Pentium[®] II Processor Specification Update

Release Date: April 1999

Order Number: 243337-025

The Pentium[®] II processor may contain design defects or errors known as errata which may cause the product to deviate from published specifications. Current characterized errata are documented in this Specification Update.

Figure 1. UP Dual Ended Termination (DET)

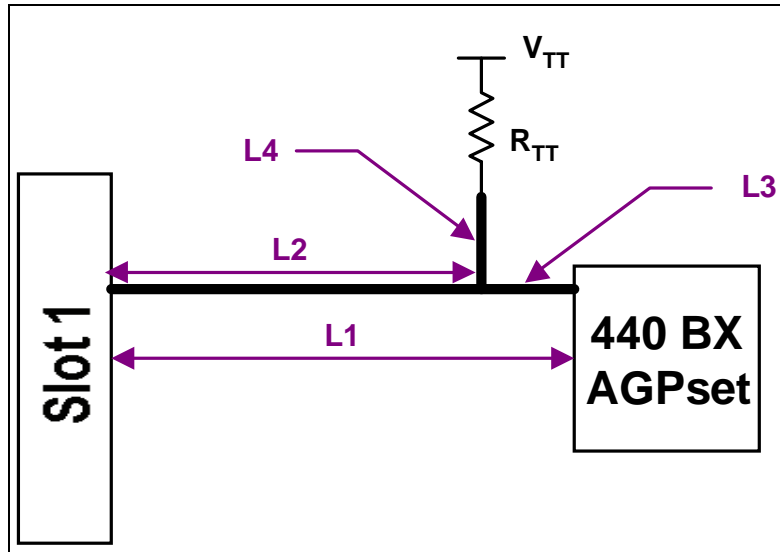
WORKAROUND: If the chipset and third party agents used with the Pentium II processor do not optimize their arbitration latency as described above, no action is required. For the 66 MHz Pentium II processor, no action is required. If agents that have implemented this optimization, by following the *100 MHz GTL+ Layout Guidelines for the Pentium® II Processor* and *Intel 440BX AGPset* for UP-SET (single-ended termination) and DP with both processors installed, no action is required. The following two cases are additional guidelines for UP-DET (dual-ended termination) and DP-DET with only one processor populated.

For UP-DET topologies (see Figure 1), the trace length $L1$ must be between 1.5" to 4.5" while using a 56 Ω termination resistor.

Figure 2. DP Dual Ended Termination (DET)

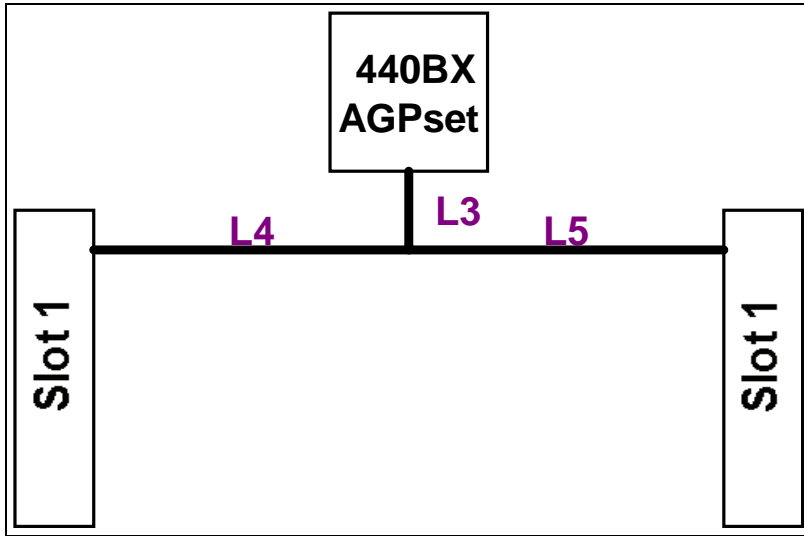
For DP topologies (see Figure 2) installed with a processor and a termination card, $L4 + L3$ or $L5 + L3$ must be less than or equal to 4.5". Additionally, for DP platforms with one processor installed, the termination card should be placed in the longer leg.

Figure 23. Processor with an Example Low Profile Heatsink Attached Using Spring Clips

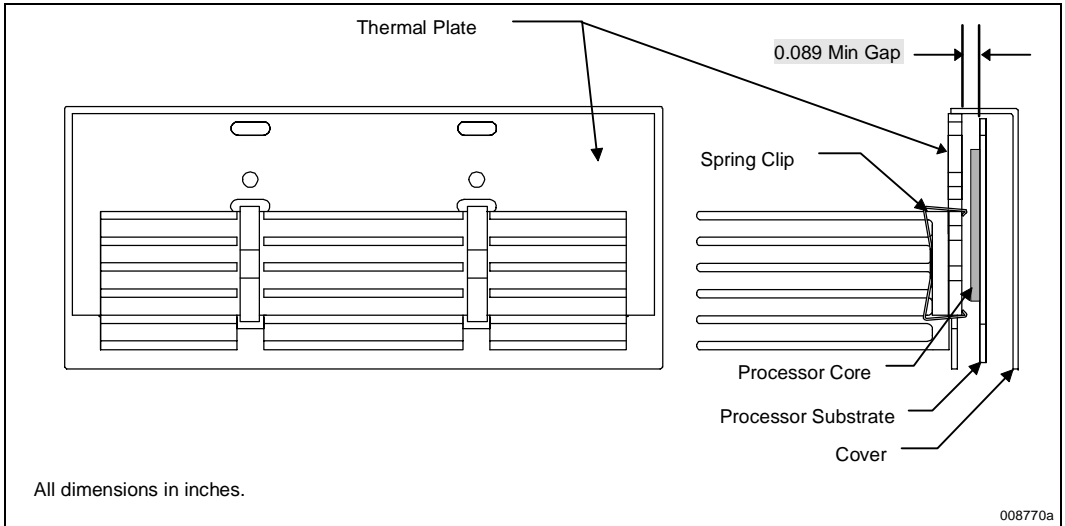
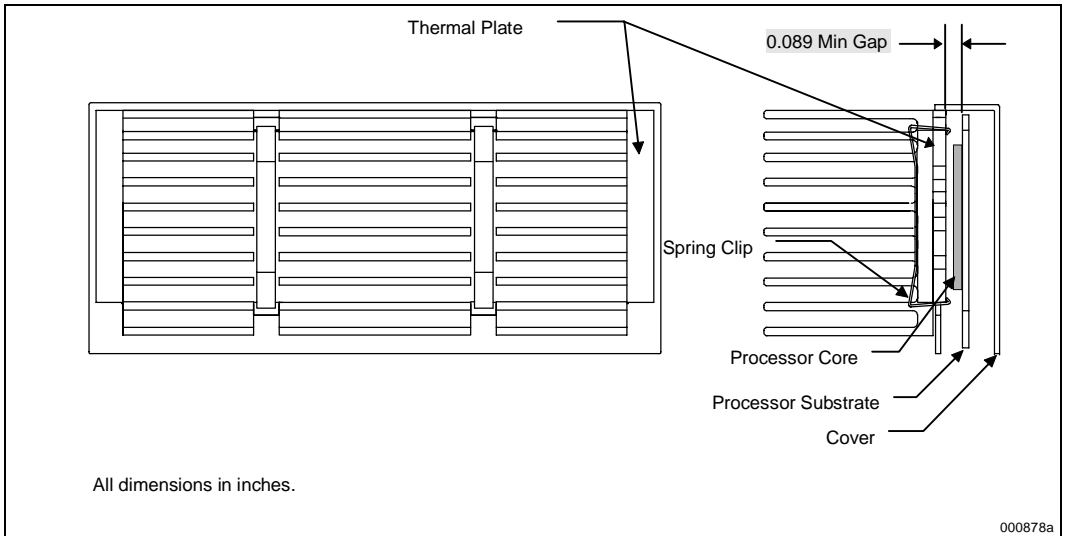
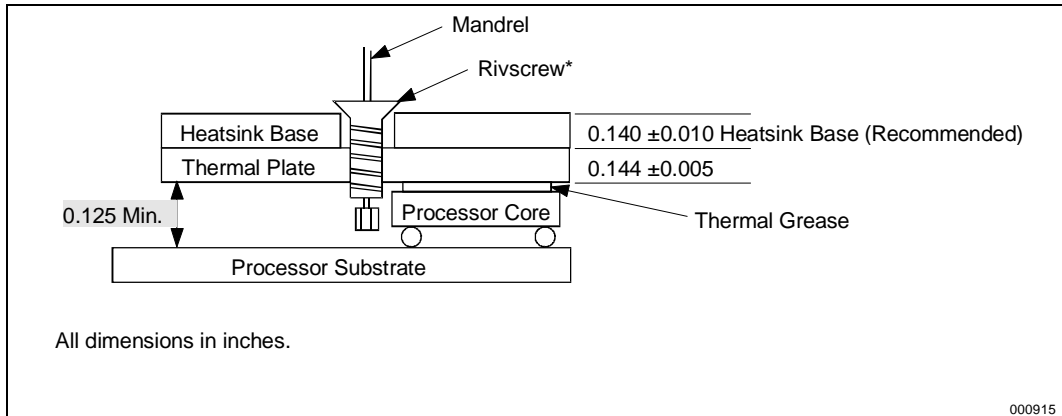
The design of the thermal plate is intended to support two different attach methods — heatsink clips and Rivscrews*. Figure 41 shows the thermal plate and the locations of the attach features. Only one attach method should be used for any thermal solution.

Figure 23 and Figure 24 illustrate example clip designs to support a low profile and a full height heatsink, respectively. The clips attach the heatsink by engaging with the underside of the thermal plate. The clearance of the thermal plate to the internal processor substrate is a minimum **0.089"** (illustrated in Figure 23 and Figure 24). The clips should be designed such that they will engage within this space, and also not damage the substrate upon insertion or removal. Finally, the clips should be able to retain the heatsink onto the thermal plate through a system level mechanical shock and vibration test. The clips should also apply a high enough force to spread the interface material for the spot size selected.

The Rivscrew attach mechanism uses a specialized rivet that is inserted through a hole in the heatsink into the thermal plate. Upon insertion, a threaded fastener is formed that can be removed if necessary. For Rivscrew attachment, the minimum gap between the thermal plate and the processor substrate is **0.125"**. For use of the Advell Rivscrew (part number 1712-3510), the heatsink base thickness must be $0.140 \pm 0.010"$. See Figure 25, Figure 26 and Figure 27 for details of heatsink requirements for use with Rivscrews.

Figure 6. BCLK to Core Logic Offset

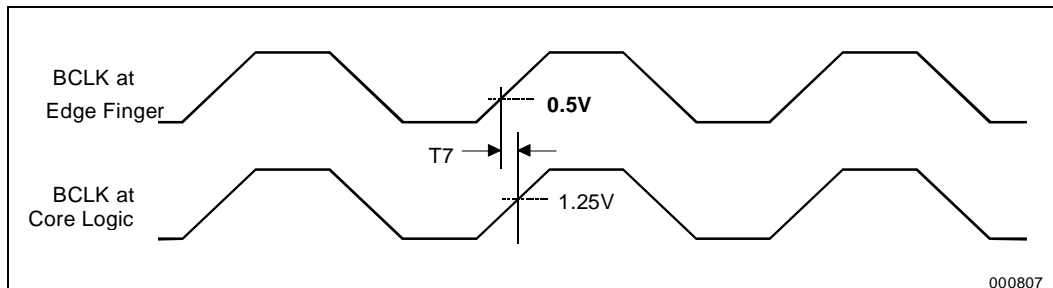
In Figure 6 of the *Pentium® II Processor at 233 MHz, 266 MHz, 300 MHz, and 333 MHz* datasheet, the following changes should be made:

Figure 7. BCLK*, PICCLK, and TCK Generic Clock Waveform

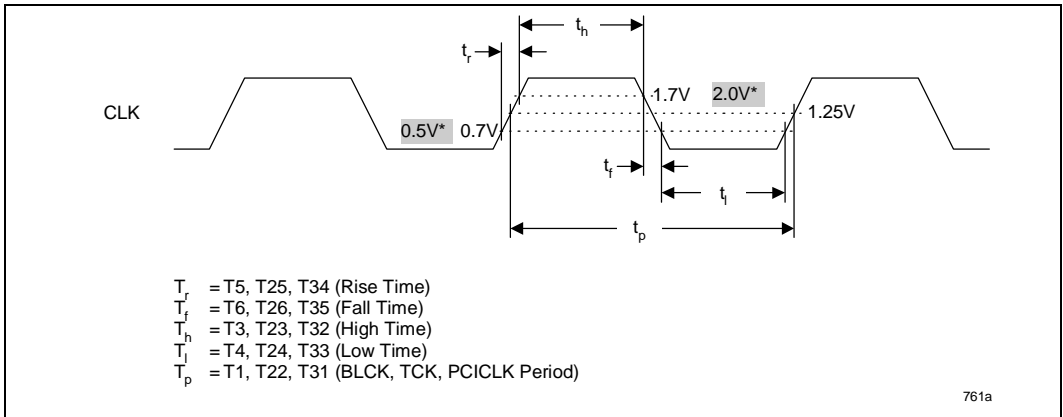
In Figure 7 of the *Pentium® II Processor at 233 MHz, 266 MHz, 300 MHz, and 333 MHz* datasheet, the following changes should be made:
